PLANNING, ZONING, & BUILDING DEPARTMENT PZ&B Staff Memorandum: Landmarks Preservation Commission

SUBJECT: COA-24-0024 177 CLARENDON AVE

MEETING: NOVEMBER 20, 2024, LPC

<u>COA-24-0024 177 CLARENDON AVE.</u> The property owners, James and Garland Alban, have filed an application requesting a Certificate of Appropriateness for the review and approval of exterior alterations including the addition of pergolas, a bay window, exterior lighting, enclosure of a garage bay, removal of select windows, and hardscape modifications for the Landmarked structure.

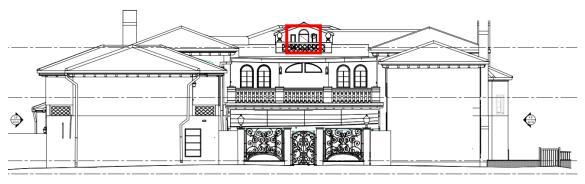
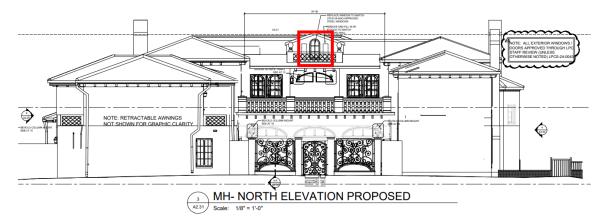
On the east façade, light fixtures will be replaced, a window and door will be removed, a new pair of 8-light casement windows will be added which is consistent with the design of other windows featured in the residence, and a garage door will be replaced to match the other existing garage doors but will be operate in an outswing rather than overhead motion to accommodate its interior retrofit. This façade features three (3) garage bays, the proposal seeks to convert the southernmost garage bay into a mudroom yet will visually remain a garage. As with other facades, the replacement of all other windows and doors was approved administratively (LPCS-24-0043).

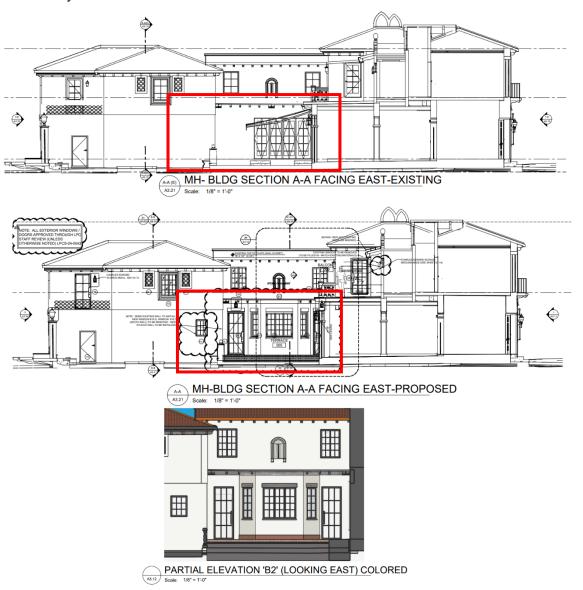
On the west façade, new exterior lighting fixtures are proposed on this façade. No further changes are proposed to the window and doors other than the previously approved replacement.
